## REQUEST FOR COUNCIL ACTION

ITEM DESCRIPTION: Final Plat #02-28 by Denny Peterson to be known as Pine Ridge Estates Fifth Subdivision. The Plat proposes to subdivide approximately 20.98 acres of land into 37 lots for single family detached dwellings and 1 outlot for a future park. The plat also dedicates the right-of-way for new public roadways. The property is located east and north of Ponderosa Drive SW and allows for the continuation of Red Pine Avenue SW.

**RE: Final Plat #02-28 by Denny Peterson to be known as Pine Ridge Estates Fifth Subdivision. The Plat proposes to subdivide approximately 20.98 acres of land into 37 lots for single family detached dwellings and 1 outlot for a future park. The plat also dedicates the right-of-way for new public roadways. The property is located east and north of Ponderosa Drive SW and allows for the continuation of Red Pine Avenue SW.**

**RE:** PINE RIDGE ESTATES FIFTH  
FINAL PLAT #02-28

PINE RIDGE ESTATES FIFTH SUBDIVISION

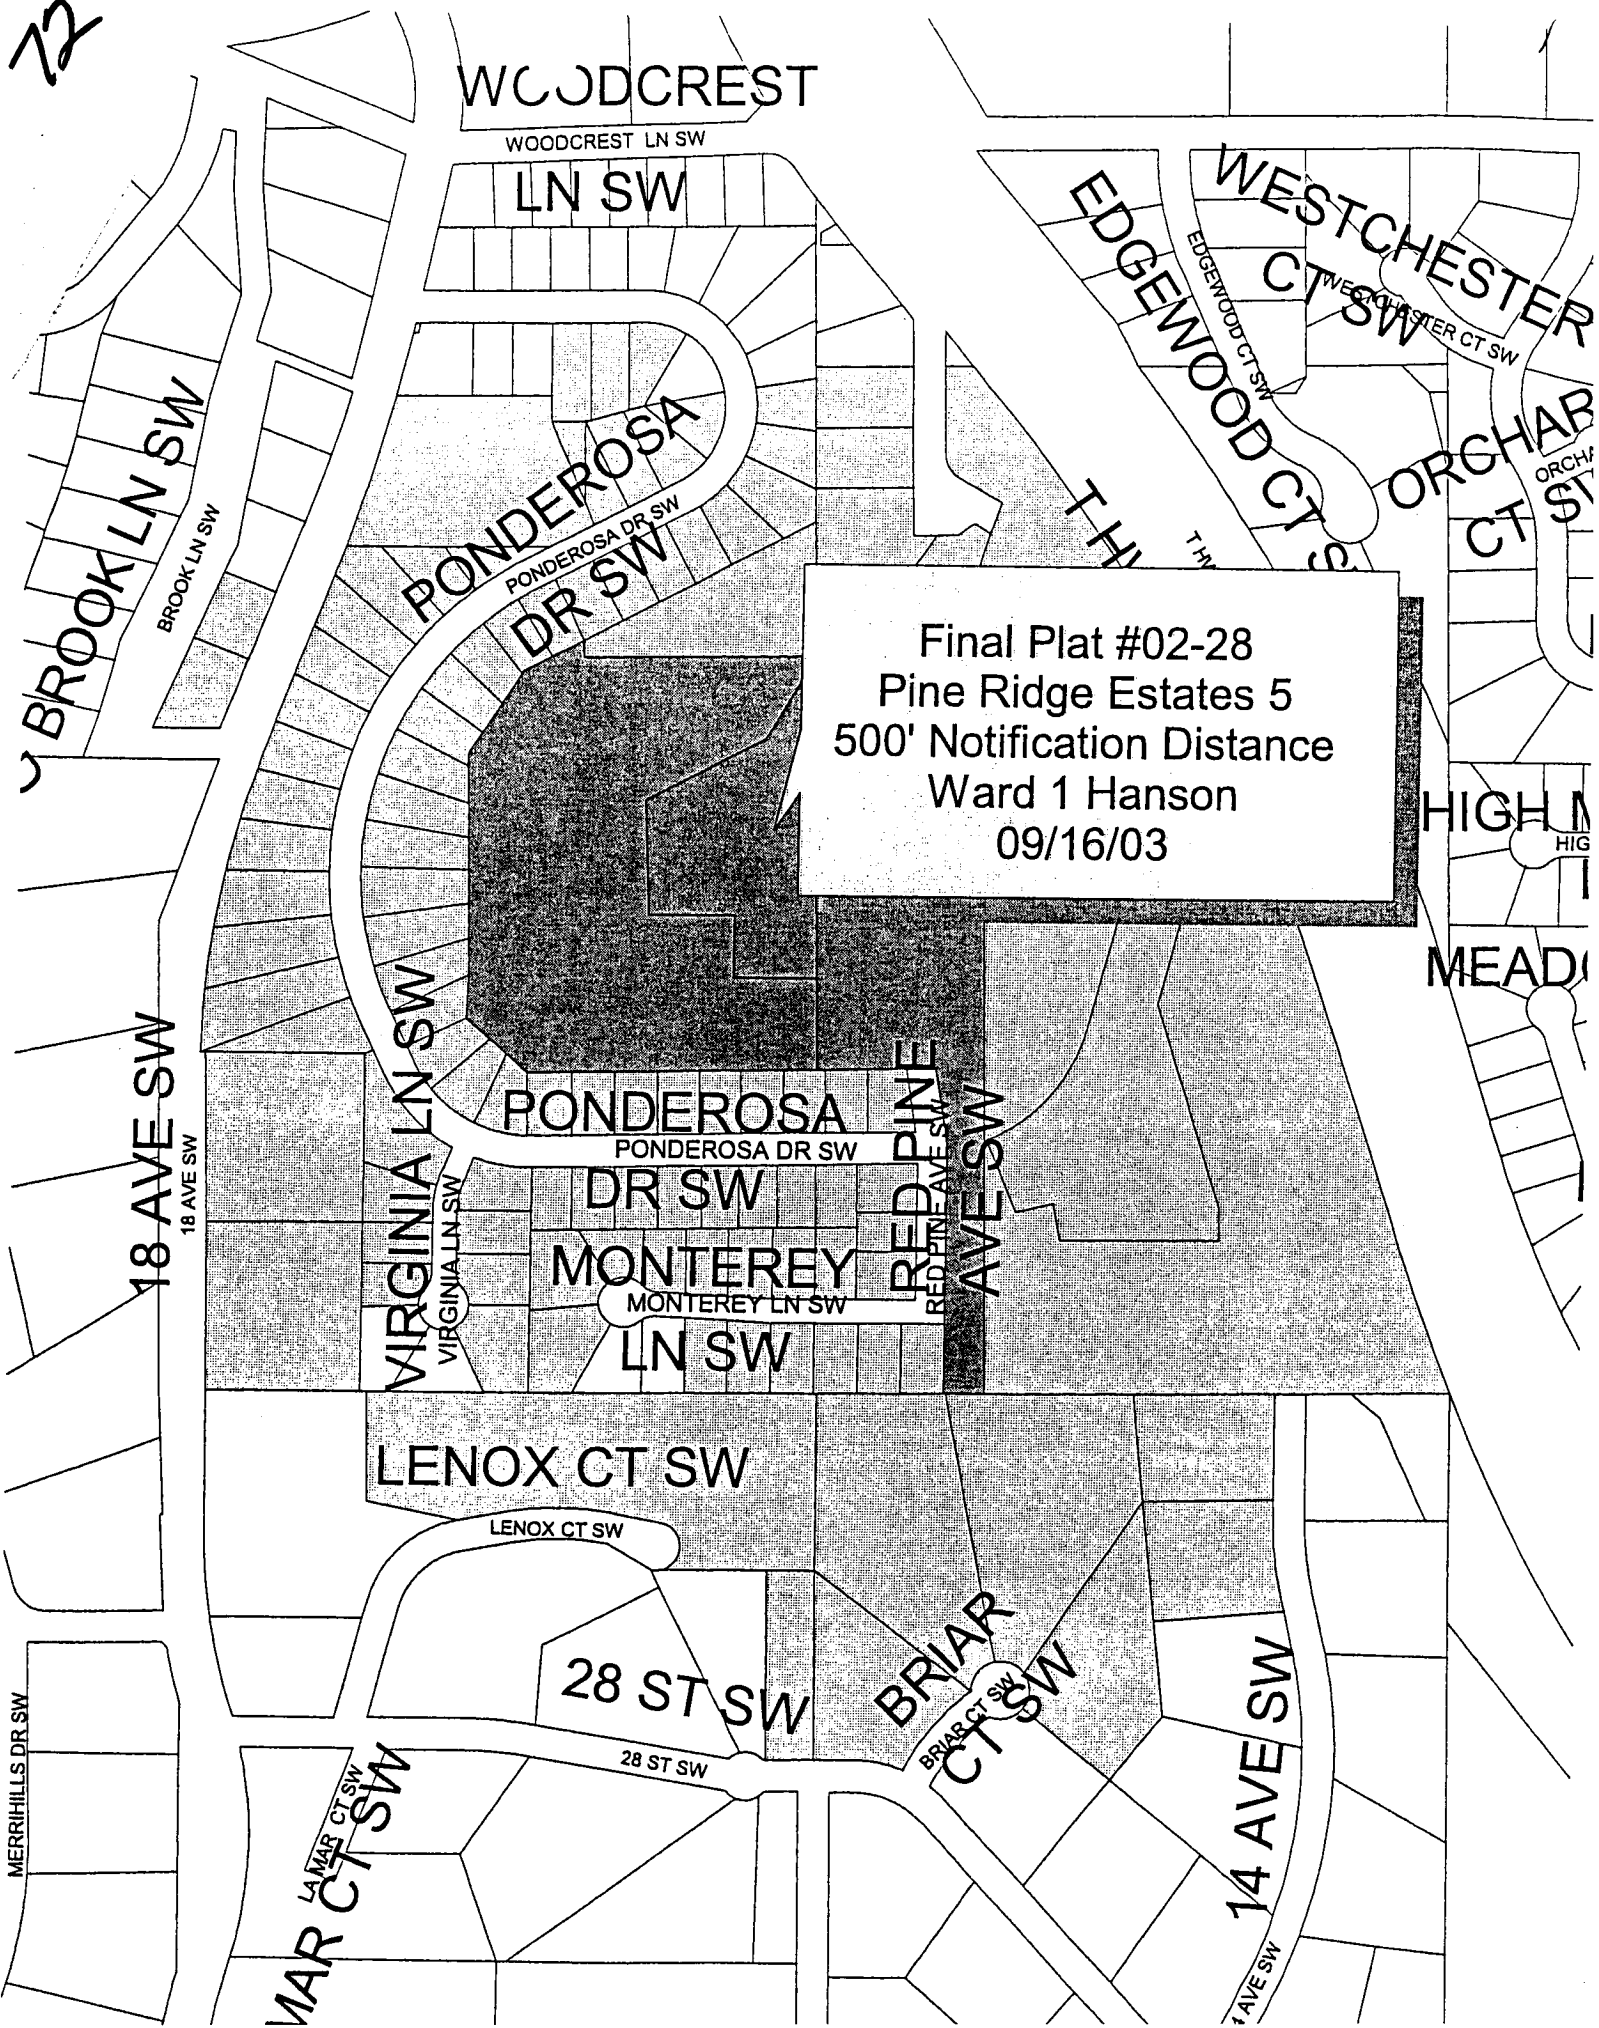
The second roadway labeled "Red Pine Avenue SW" is a continuation from the south and is designed with a 60' right-of-way. The roadway type for Red Pine Avenue SW north of the intersection with Redwood Lane SW needs to be changed. Change that portion of Red Pine Avenue SW to "Red Pine Lane SW".

The third roadway labeled as "Woodcrest Lane SW" is designed with a 66' right-of-way. This roadway needs to be changed as it is likely the roadway will not connect to the existing Woodcrest Lane SW further to the north in Woodland Hills Subdivision. Change the roadway within this plat to "Ponderosa Place SW"

The fourth roadway labeled as "Monterey Drive SW" is designed with a 60' right-of-way. This is an incorrect roadway type. Change Monterey Drive SW to "Monterey Street SW".

1. Monterey Drive SW is using an incorrect roadway type.

2. Red Pine Avenue north of its intersection with Redwood Lane SW also needs the roadway type changed.

3. Woodcrest Lane SW as platted, needs be changed as it is likely the roadway will not connect to the existing Woodcrest Lane SW further to the north in Woodland Hills Subdivision.

1. *Prior to recording, the final plat shall be revised, as follows:*
  - a. *Rename the roadway labeled Monterey Drive SW to "Monterey Street SW".*
  - b. *Change the portion of Red Pine Avenue SW north of the intersection with Redwood Lane SW to "Red Pine Lane SW".*

- c. *Rename Woodcrest Lane SW to "Ponderosa Place SW".*
2. *A GIS Impact Fee and E911 Addressing Fee shall be assessed and must be paid prior to recording the final plat, per the September 25, 2003 memorandum from Rochester-Olmsted Planning Department – GIS Division.*

**RECOMMENDATION:** Change Monterey Drive SW to **MONTEREY STREET SW**.

**RECOMMENDATION:** Change that portion of Red Pine Ave SW to **RED PINE LANE SW**.

**RECOMMENDATION:** Change Woodcrest Lane SW in this plat to **PONDEROSA PLACE SW**.
